Permitting Decisions - Variation

We have decided to grant the variation for East Northants Resource Management Facility operated by Augean South Limited.

The variation number is EPR/TP3430GW/V007.

Figure 1 – Conceptual Site Model (reproduced from application EPR/TP3430GW/V007 dated May 2021)

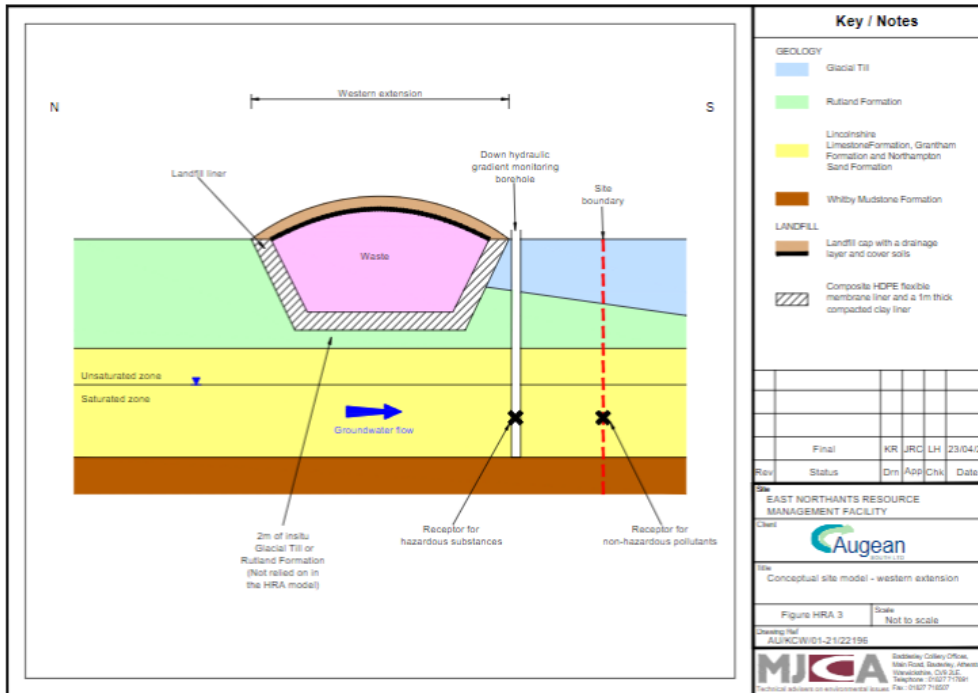
The operator's desk top study and ground investigations informed the conceptual site model (illustrated in figure 1 below). However, as described above in the Site Investigation section further work is necessary to ascertain the extent of the doline area. We have agreed that the operator will undertake site investigation works, in the 150 m wide zone, to include (but not be limited to):

- finding the cavities and areas of increased fracturing;
- determining what aperture is significant and understand further how they are formed;
- ascertaining the width of the stand-off areas;
- providing the revised detailed design of the containment system.

We require this work to be done as we need to ensure that the subgrade beneath the site is stable and will support the engineered lining system. The extent of the doline areas needs to be understood and no landfilling will be undertaken in the 150 m wide zone until the site investigation has been undertaken and we are satisfied with the revised site design. If fracture areas are found, based on the results of the work under the pre-operational condition 4 a to c we would not allow any landfill development above areas in which cavities are identified. However, the 150 m wide zone may be reduced if no evidence of cavities is found. (See also the Stability Risk Assessment (SRA) section below).

- clarify their interpretation of how dolines are formed; and
- clarify what fracture aperture is considered to be significant when considering effect on the containment system, and long-term development of cavities.

However, to ensure the site design is appropriate in and around the karstic/doline area, we have included a pre-operational condition 4b & c in the permit to undertake an additional site investigations to ascertain extent of the doline area, fully understand how any apertures are formed or made worse (possibility likely to be via surface water/groundwater actions and interactions and sediment movement) and revise the site design to account for the findings of the investigation.

Figure 2 – Groundwater contours (reproduced from application EPR/TP3430GW/V007 dated May 2021)

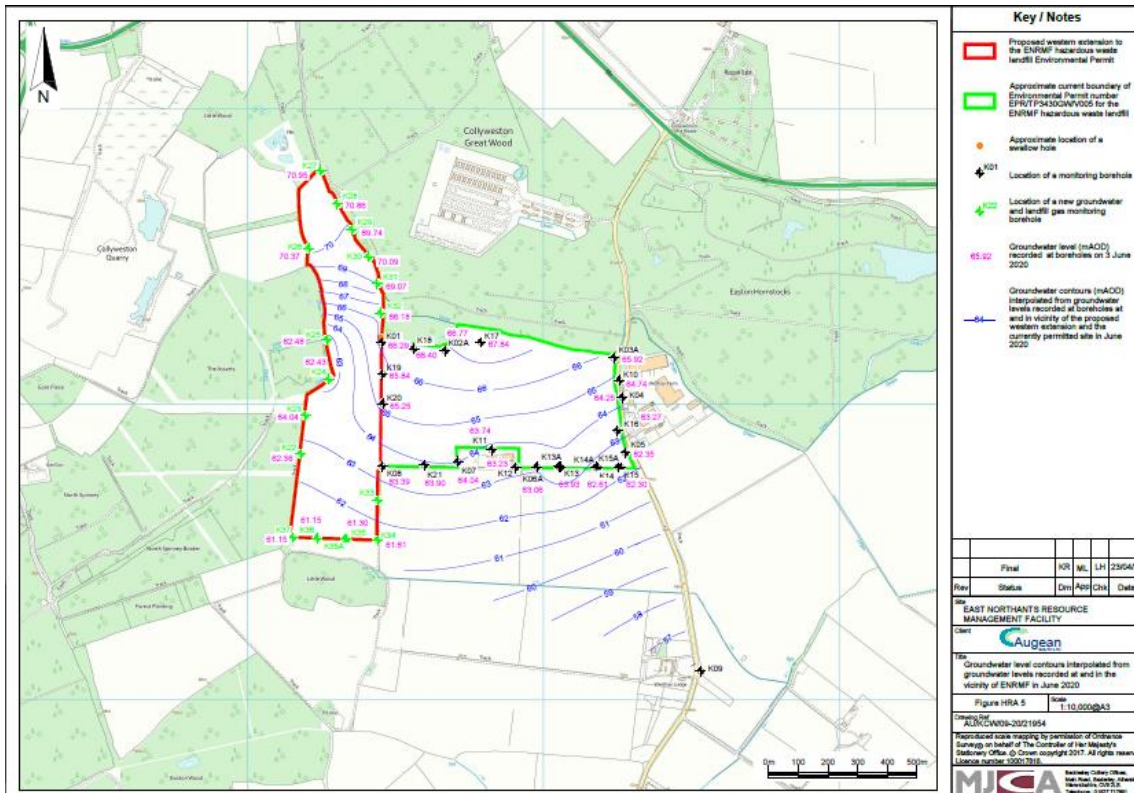
features such as swallow holes and doline depressions have been recorded in the vicinity of the site. Generally the groundwater flows in N-S direction, but also falls to the west - southwest in the mid to southern part of the extension (see figure 2).
